No.	Date	Description
1	2025-09-19	Add No. 1
2	2025-09-30	Add No. 2

**WCFPD Station 3**  
**Wright City Fire Protection District**  
9 Highway WW  
Wright City, MO 63390

**JOINTING PLAN**

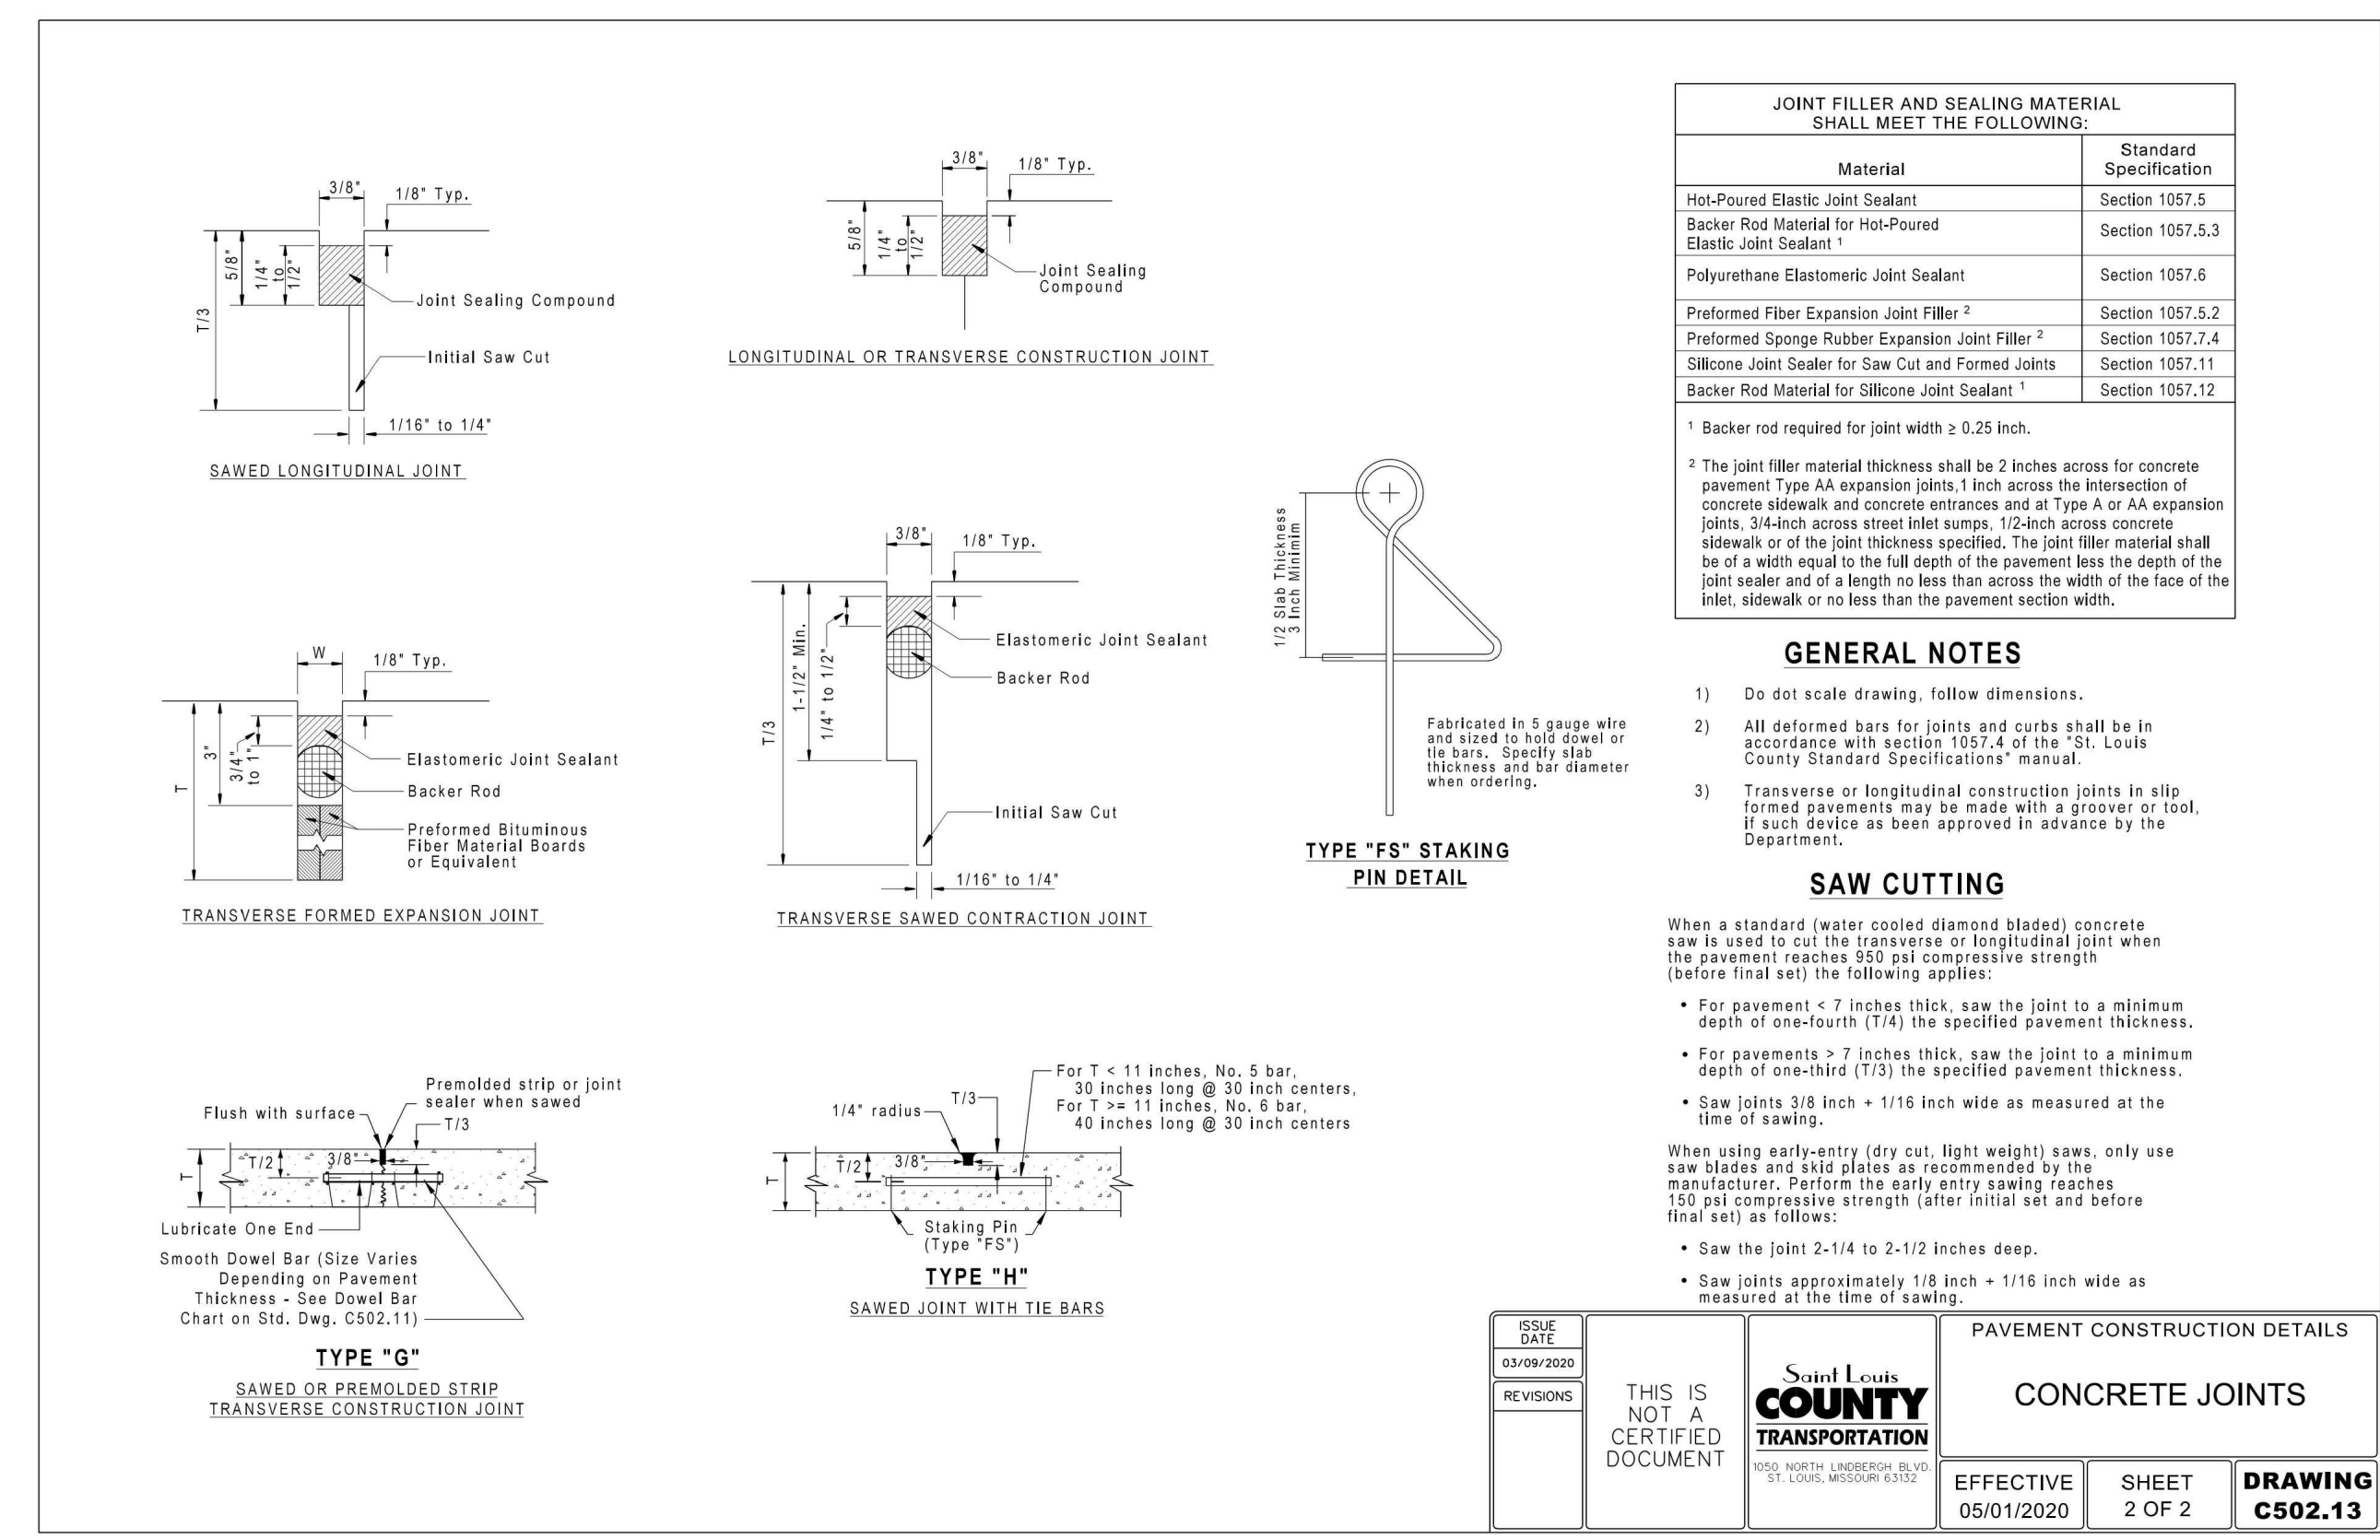
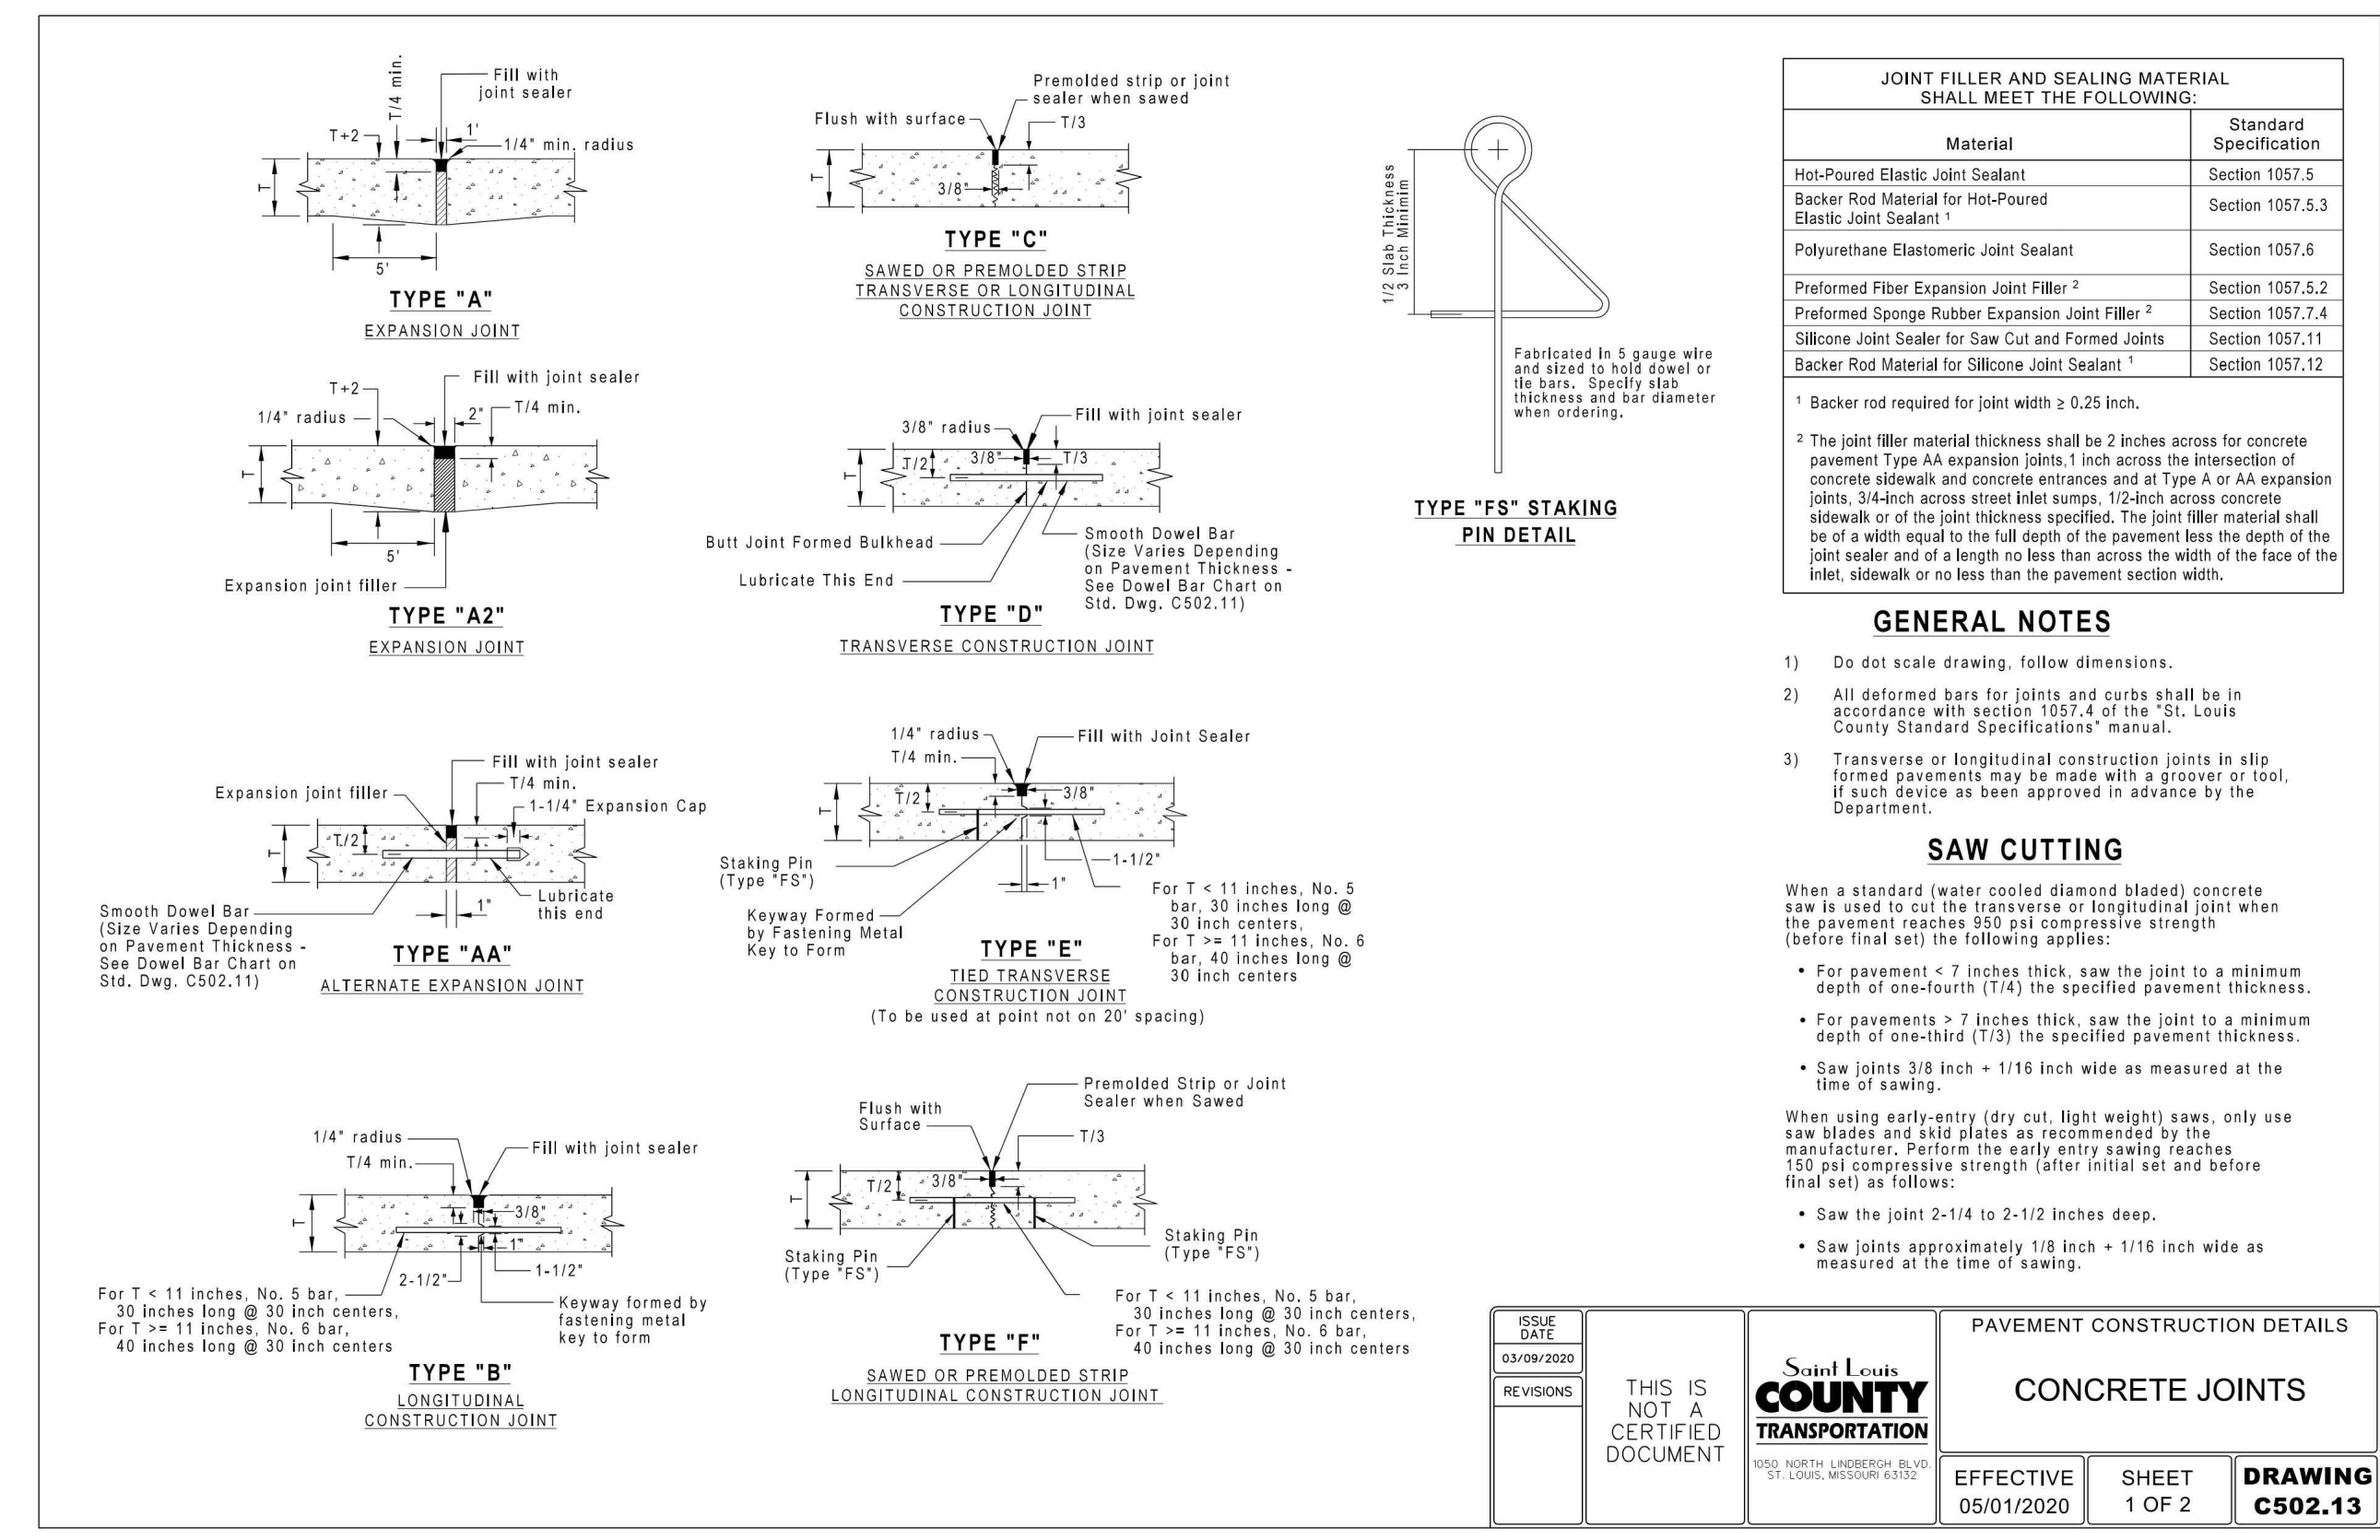
- 5) Sheet C201 – JOINTING PLAN
  - a. ADD new sheet.
- 6) Sheet C300 – GRADING PLAN
  - a. ADD spot shots for the corrected pavement.
  - b. REVISED grading on the living quarters side.
